1st Review
PRCCP20240569
June 2024

ASH DEVELOPMENT, LLC
EAST TOWN CROSSING
PUYALLUP, WA

PAVEMENT MARKING &
SIGNING PLANS - PHASE 1

TRAFFIC SIGNAL PLANS - PHASE 1

PM-01
SHEET:
OF

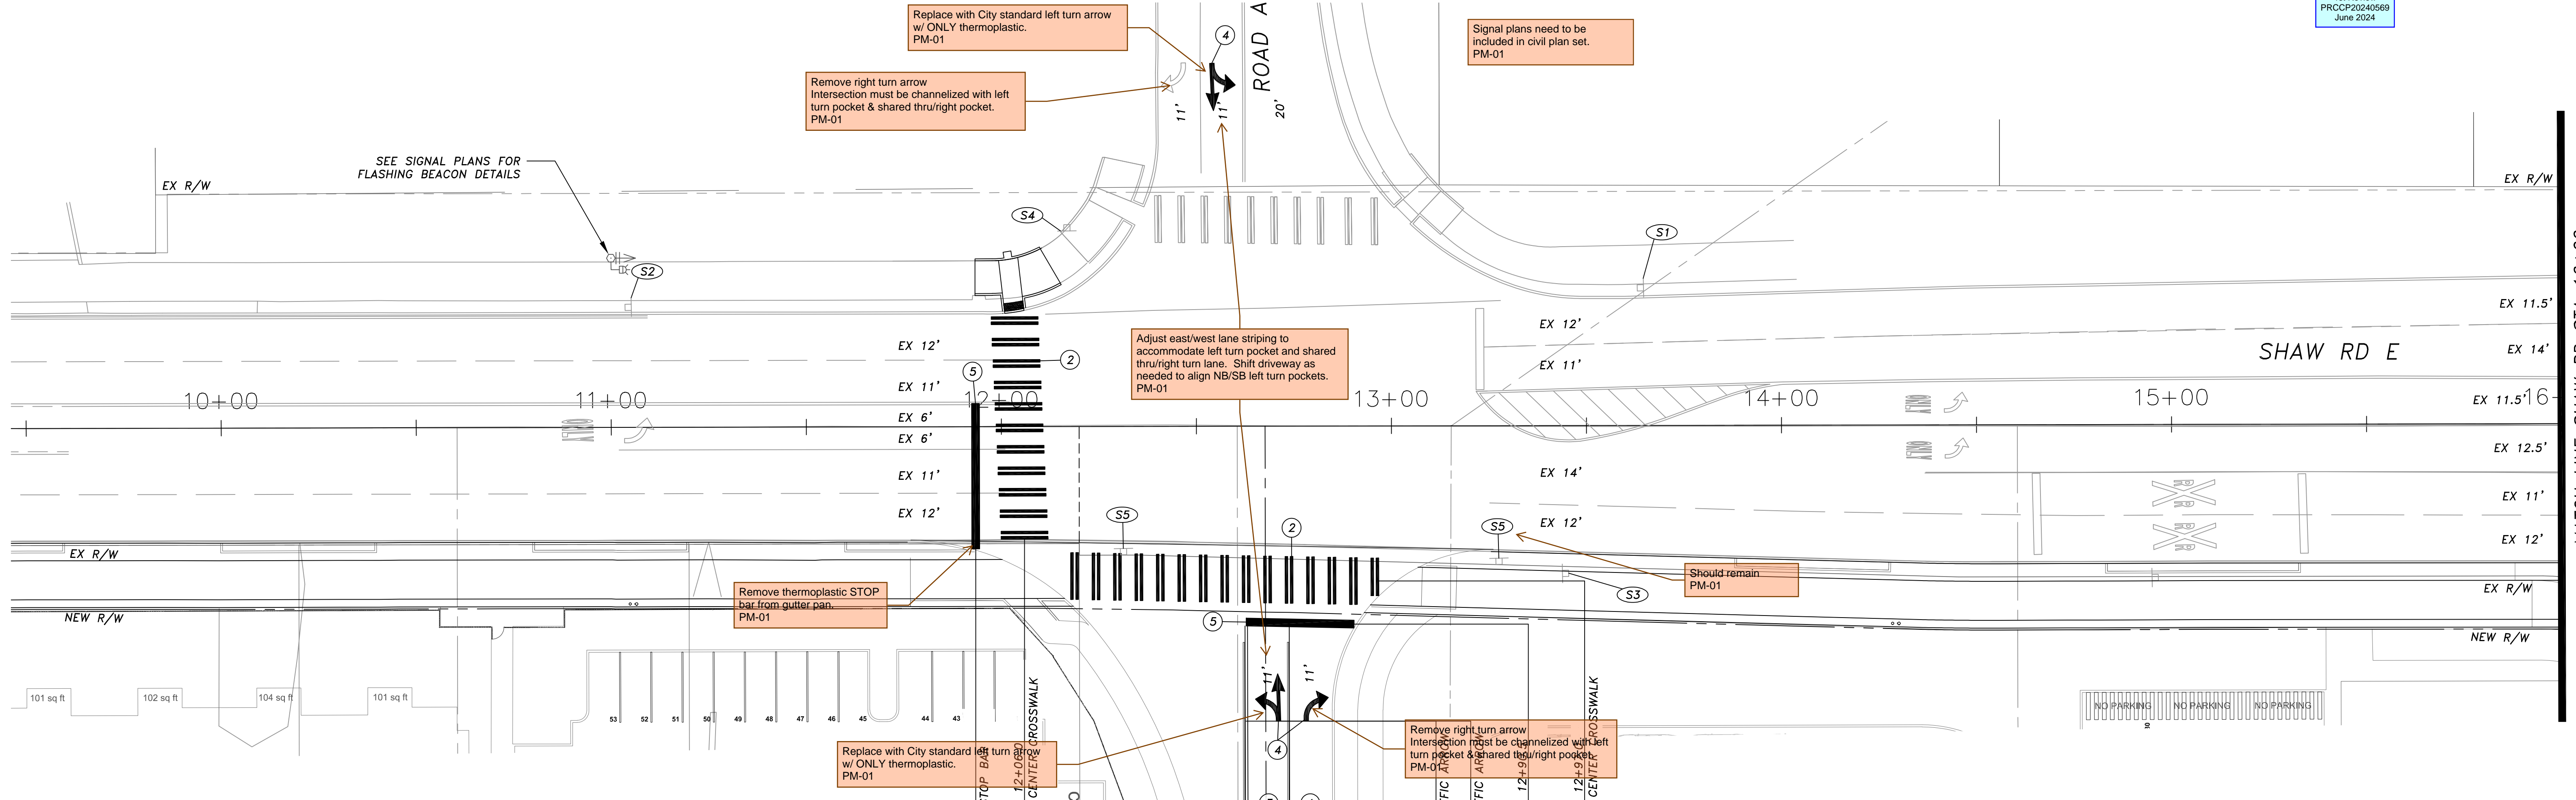
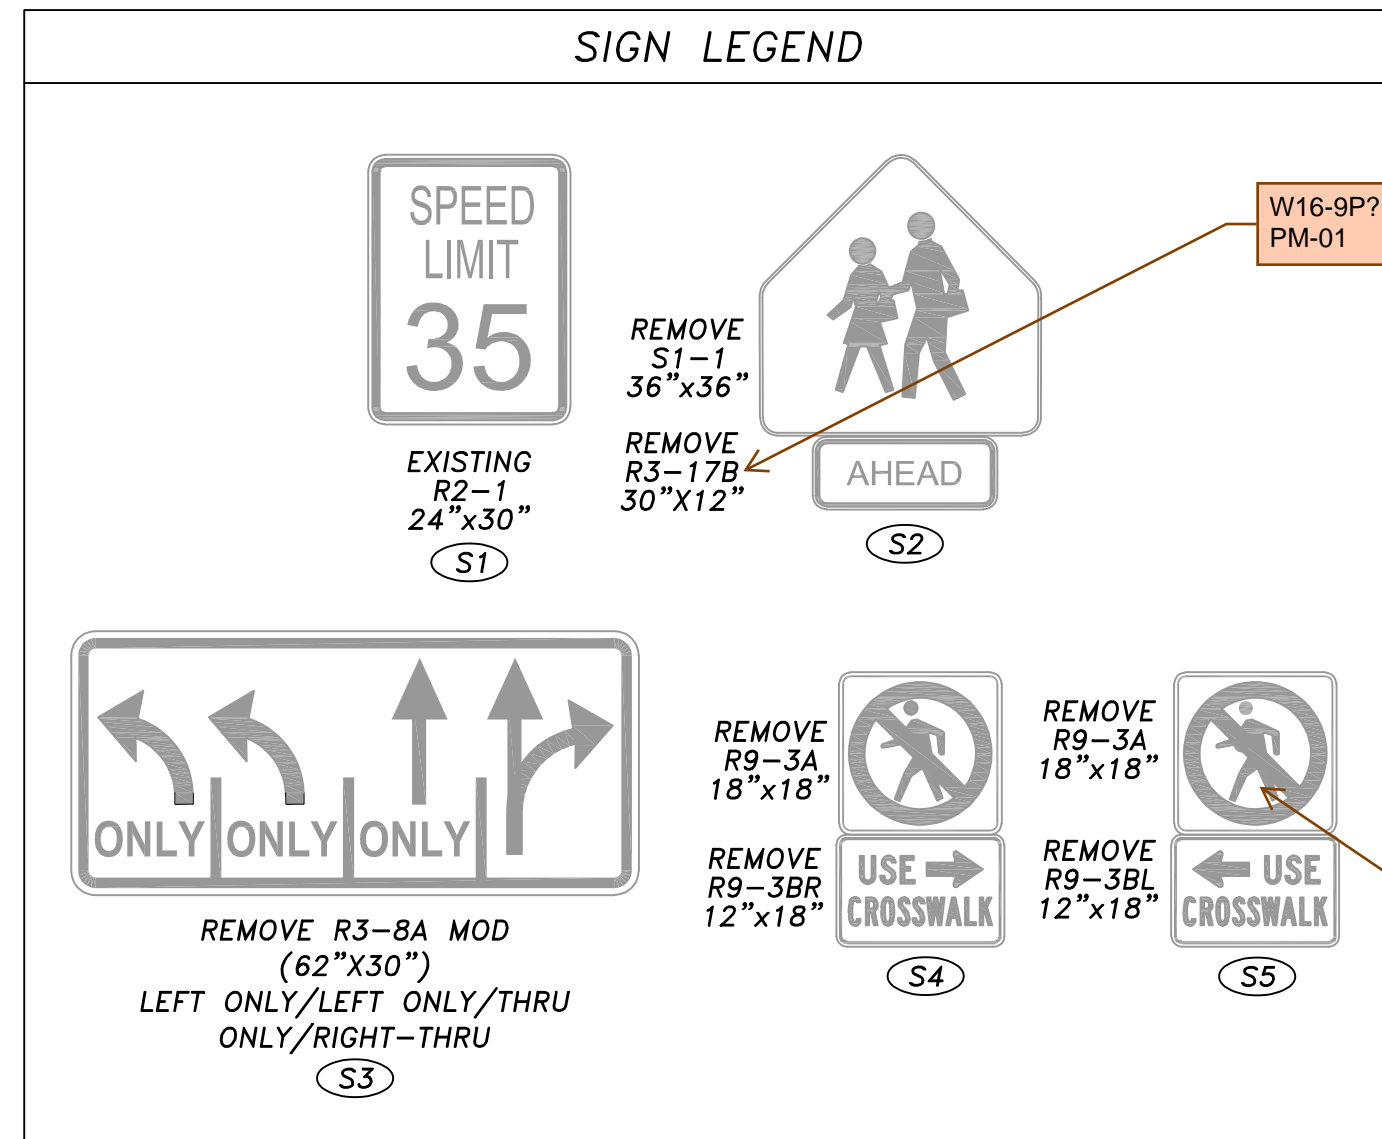
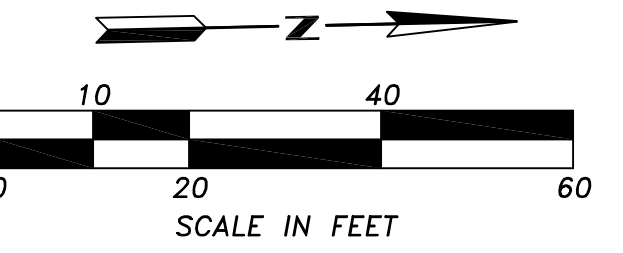
4. CONTRACTOR SHALL COORDINATE WITH CITY SIGN SPECIALIST, ~~TED SCHUMAN, (253.405.4389)~~ PRIOR TO SIGN INSTALLATIONS.
5. THE CONTRACTOR IS RESPONSIBLE FOR INSTALLING ALL SIGNS AND CHANNELIZATION PER CITY OF PUYALLUP STANDARDS. CONTRACTOR SHALL LAYOUT OUT ALL SIGNS AND CHANNELIZATION, AND THEN CONTACT PUYALLUP, AT 253.405.4389, 48-HOURS IN ADVANCE OF INSTALLATION TO VERIFY LAYOUT.

- ① EXISTING R2-1 "SPEED LIMIT" SIGN AND EXISTING POST TO REMAIN. PROTECT DURING CONSTRUCTION.
- ② REMOVE EXISTING S1-1 AND R3-17B SIGNS AND POST AND RETURN TO CITY. RESTORE AREA TO MATCH SURROUNDING.
- ③ REMOVE EXISTING R3-8A MOD SIGN AND POST AND RETURN TO CITY. RESTORE AREA TO MATCH SURROUNDING.
- ④ REMOVE EXISTING R9-3A SIGN AND R9-3BR SIGN AND RETURN TO CITY.
- ⑤ ~~REMOVE EXISTING R9-3A SIGN AND R9-3BL SIGN AND RETURN TO CITY.~~

remain and point to southern leg of this intersection. PM-01

Should Remain PM-01
